RE: Notice of Technical Completeness
Major Modification - Change in Vertical Elevation
Killona Ventures L.L.C.
Type III Construction and Demolition Debris Landfill
AI # 92039/D-089-11377/P-0355/ PER20060002
St. Charles Parish

RE: Solid Waste Permit Modification
Killona Ventures Landfill
5900 LA Highway 3127
Killona, Louisiana 70066
Site ID No.: D-089-11377; Permit No.: P-0355
Permit Activity No.: PER20060002
✓ Agency Interest No.: 92039
Tetra Tech EM Inc. Project No.: P4060

KILLONA VENTURES, LLC
SOLID WASTE PERMIT MODIFICATION

RE: Notice of Deficiency (NOD)
Technical Review # 1 Permit Modification
Change in Vertical Elevation
Killona Ventures L.L.C.
Type III Construction and Demolition Debris Landfill
AI # 92039/D-089-11377/P-0355/ PER20060002
St. Charles Parish

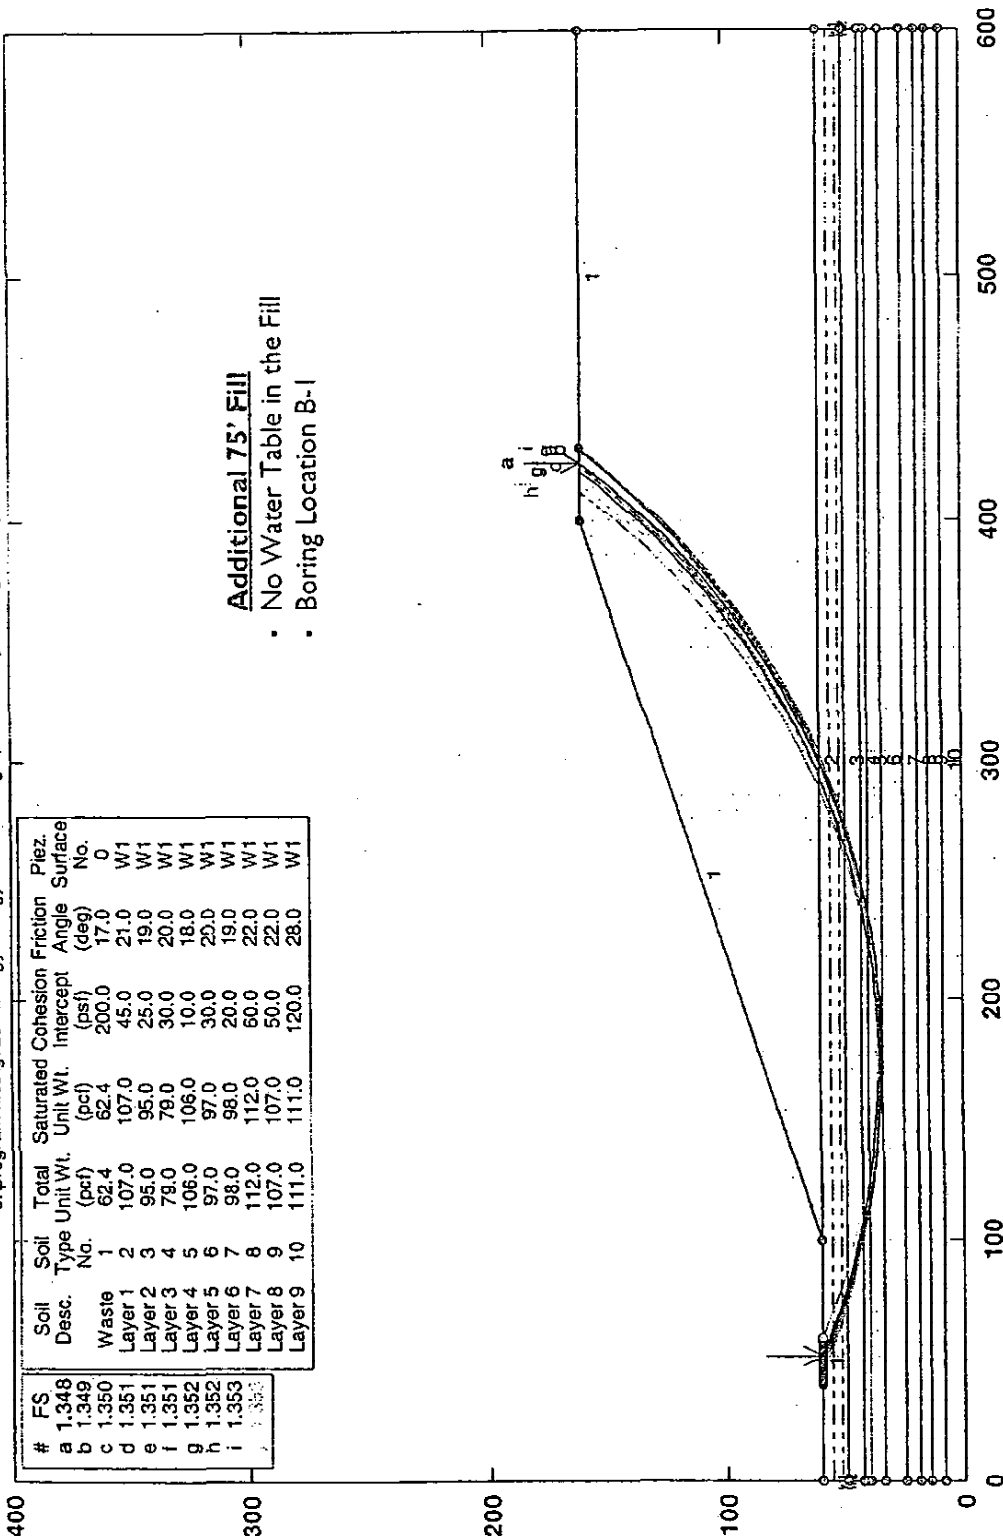
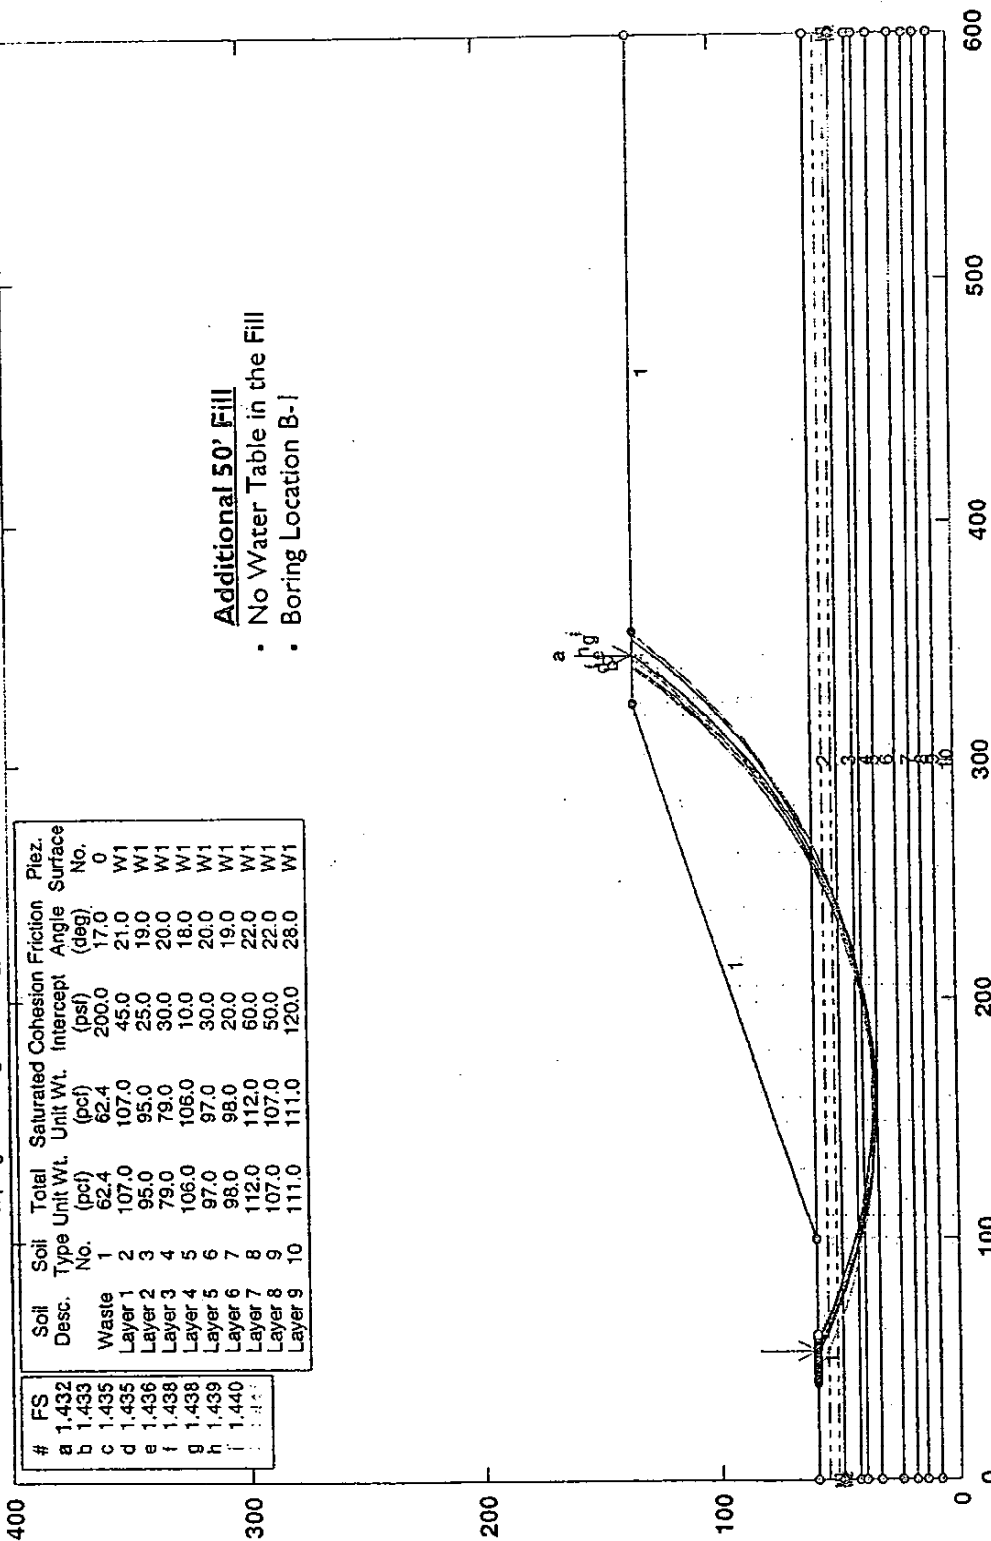
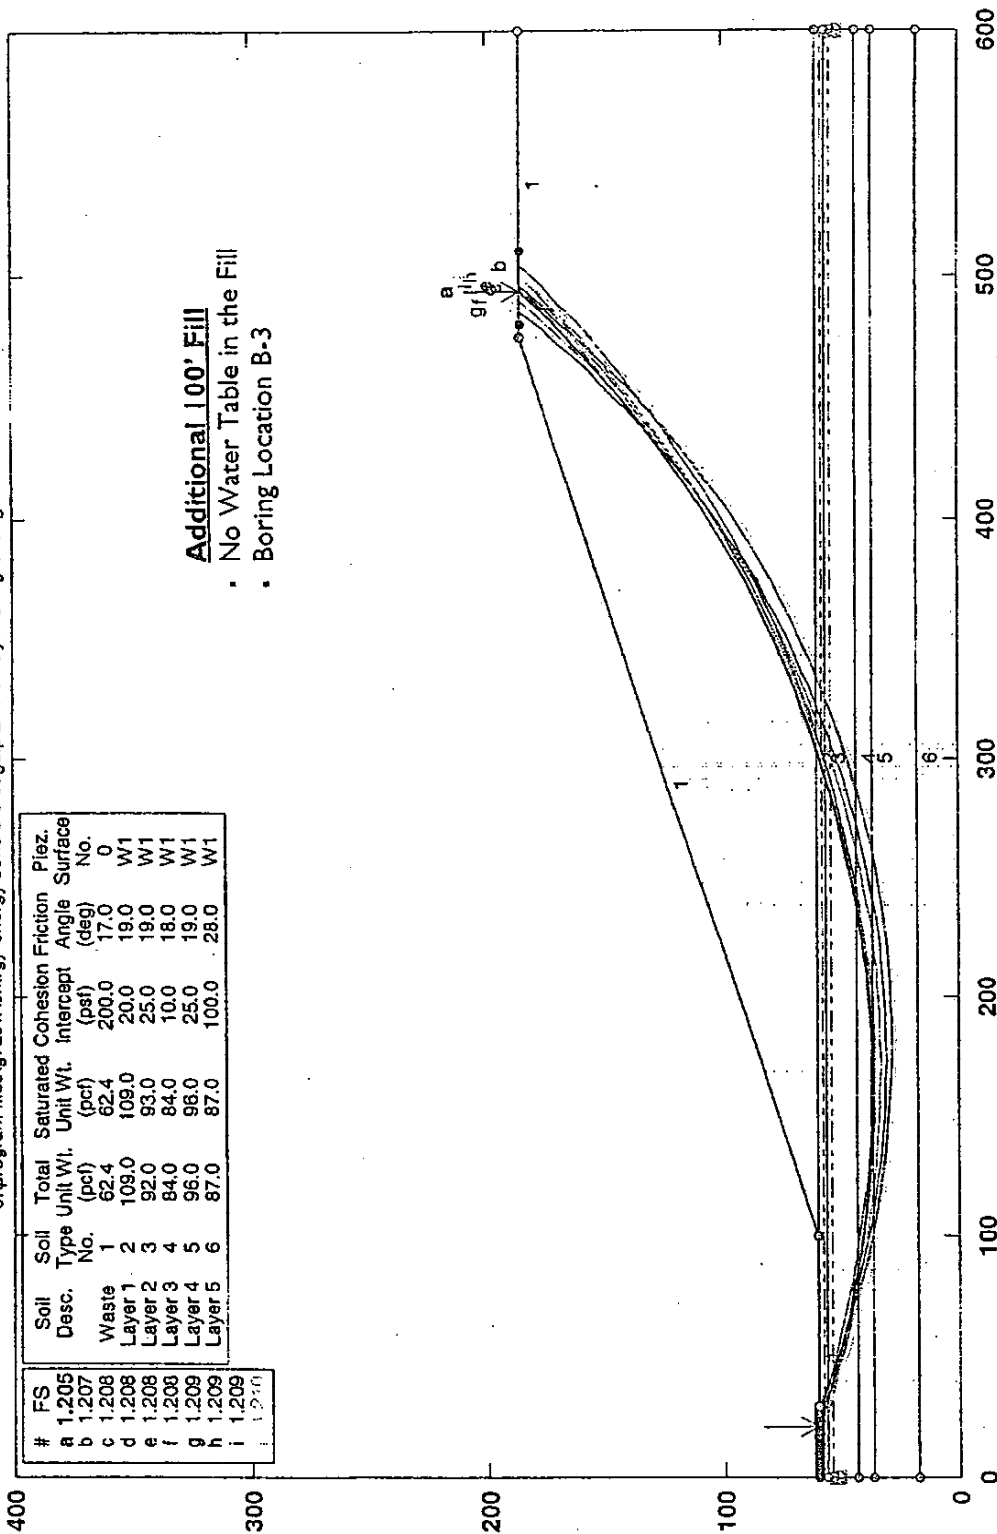
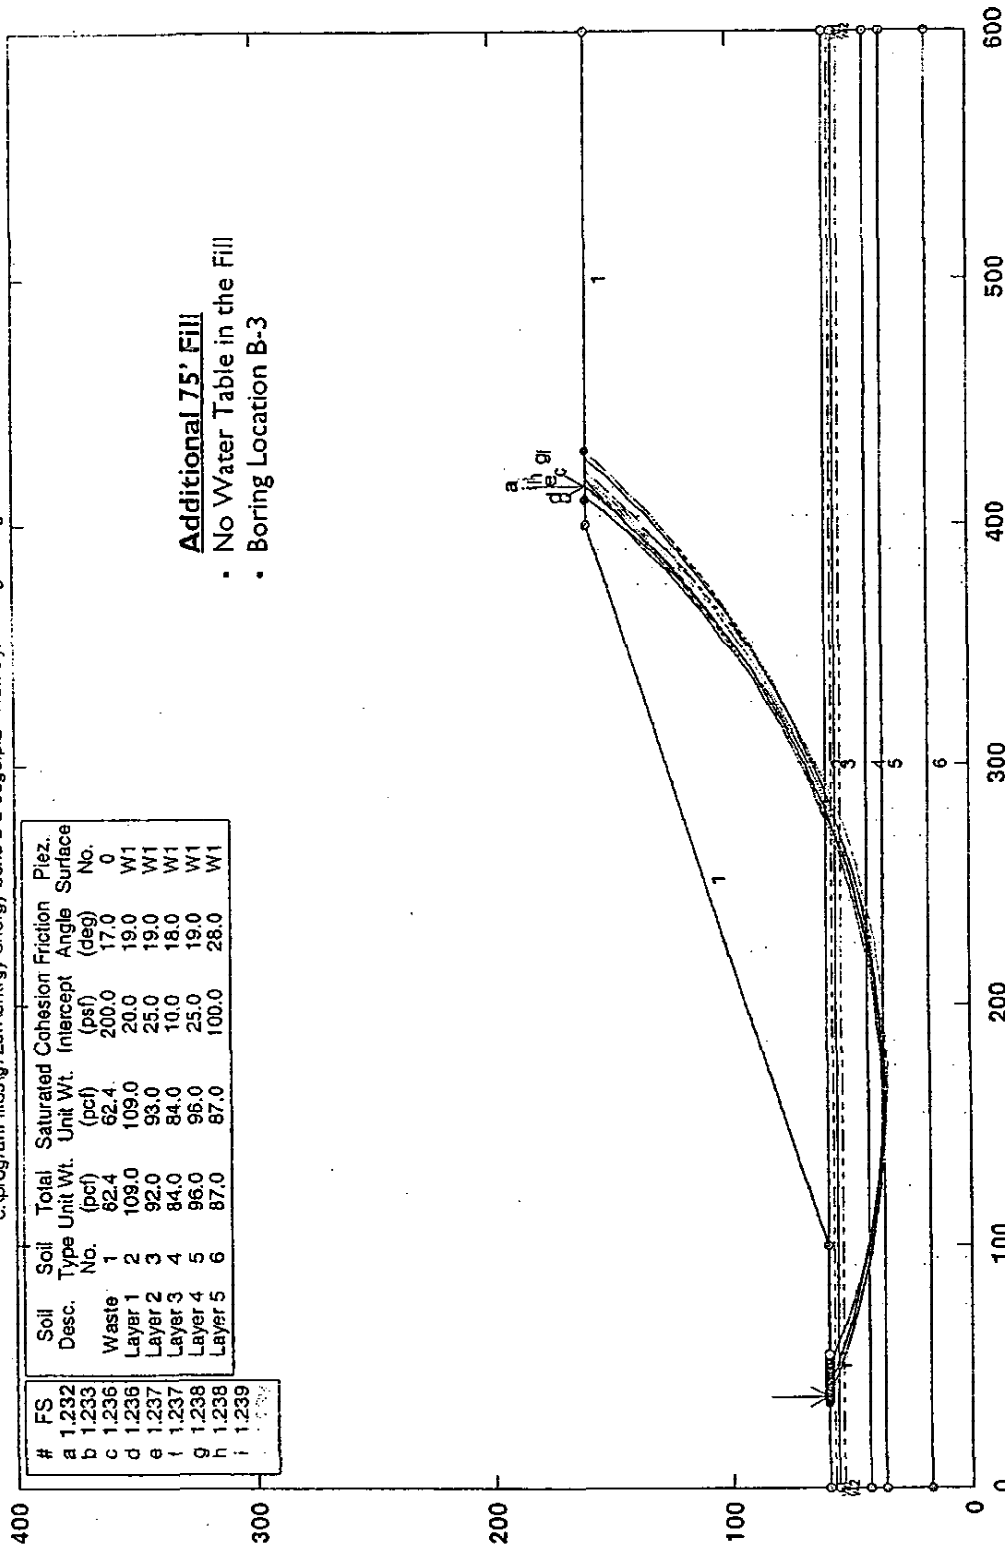
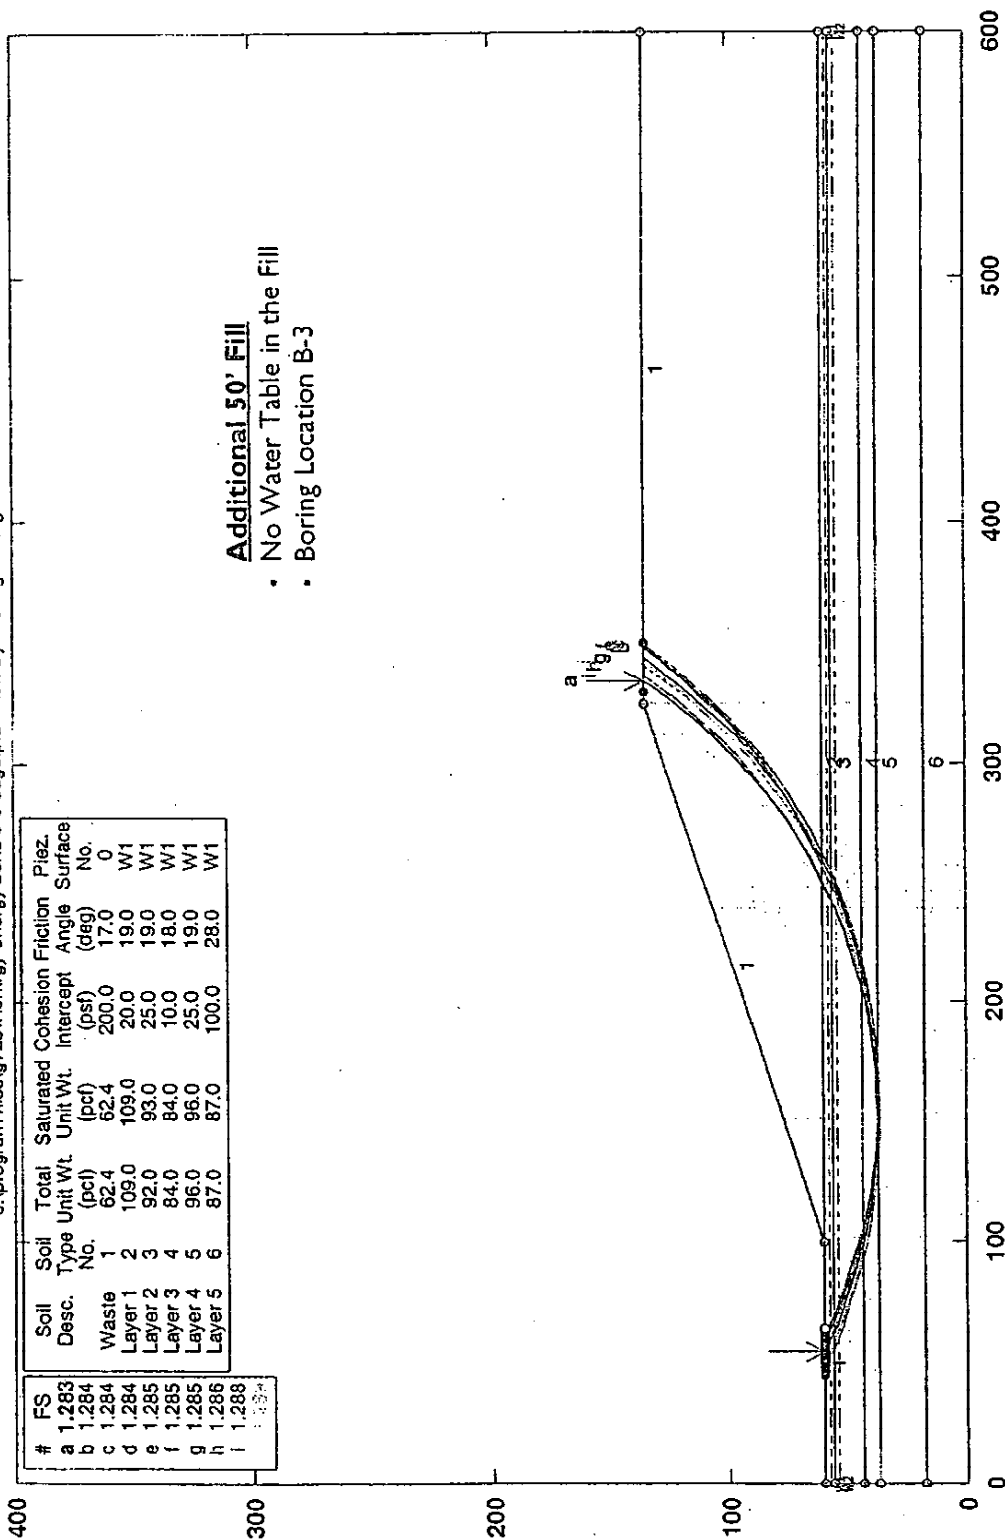
Please provide the background information used to analyze the stability of the proposed height. Provide justification demonstrating the locations chosen to represent the most critical location.

Appendix A Please provide the background information used to analyze the stability of the proposed height. Provide justification demonstrating the locations chosen represent the most critical locations.

The data used to develop the input parameters to execute the GSTABL7 model are provided on the soil boring logs provided in Appendix A. The location of the soil borings and a cross section of the stratigraphy at the site are provided in Appendix A. The soil boring logs were developed by others during the initial permitting process for the Killona facility. A copy of the geotechnical report is provided in Appendix A.
